**Summary:** Carnaud Metalbox Engineering introduces felt seals to replace the existing energised spring seal on the Flanger and Light Tester vacuum manifolds for the 3400 Die Necker, reducing machine downtime and maintenance.

**NOTE:** For further information regarding this Technical Bulletin please contact either of the contacts below quoting Technical Bulletin number **TB3400-023** and your machine Serial Number. A complete library of technical bulletins are available on the company web site.

Figure 1

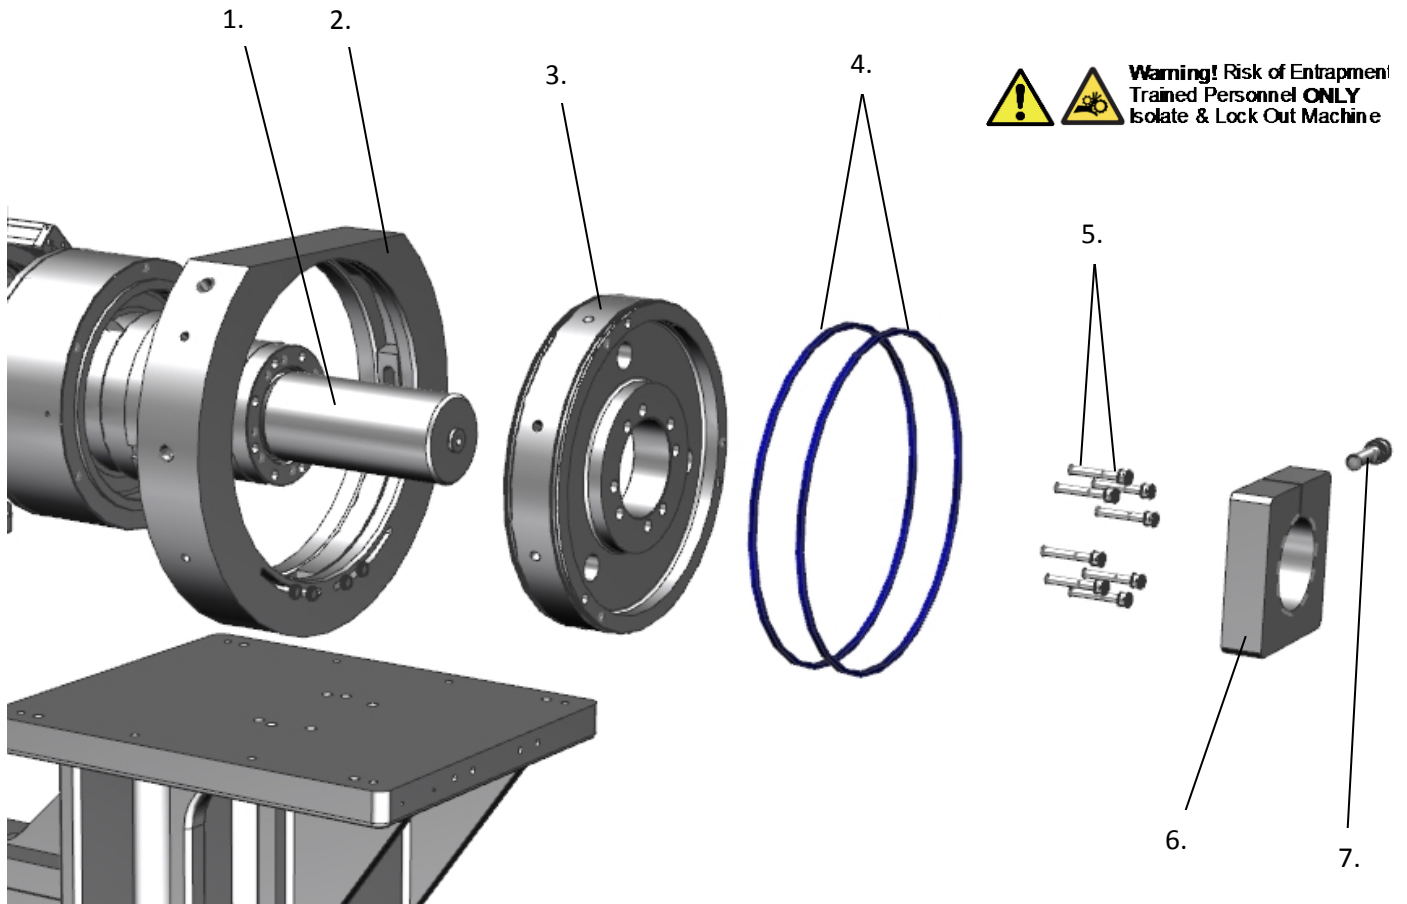
As a result of redesign, Carnaud Metalbox Engineering has changed the original energised spring seals to felt seals (Part No. 23183402). This type of seal offers an improved and lasting closure resulting in a prolonged vacuum supply to the Flanger and Light Tester process stages on the 3400 Die Necker. Through enhanced durability the new felt seals require less maintenance than the previous energised spring seal.

- Remove the end cover from the rear of the Flanger/ Light Tester station (see Section 3 of the 3400 Die Necker Operating and Maintenance manual).
- Loosen the pinch bolt (Figure 1(7)) securing the collar (6) around the main shaft (1). Remove the collar.

- Remove 8 x cap head screws (5) securing the spigot timing ring (3) in position. Carefully remove the spigot timing ring, complete with used seals.
- Remove then discard the used seals before inspecting the spigot timing ring for signs of damage/ wear, cleaning as necessary.

- Clean the seal grooves around the outer edge of the spigot timing ring, making sure they are free of any burr or debris.
- Fit the replacement seals into the seal grooves, first applying Loctite 431 adhesive all the way around the circumference of the groove to secure the seals in position.

- Re-assemble all components making sure that the spigot timing ring is correctly orientated inside the outer timing ring (2) before securing in position.
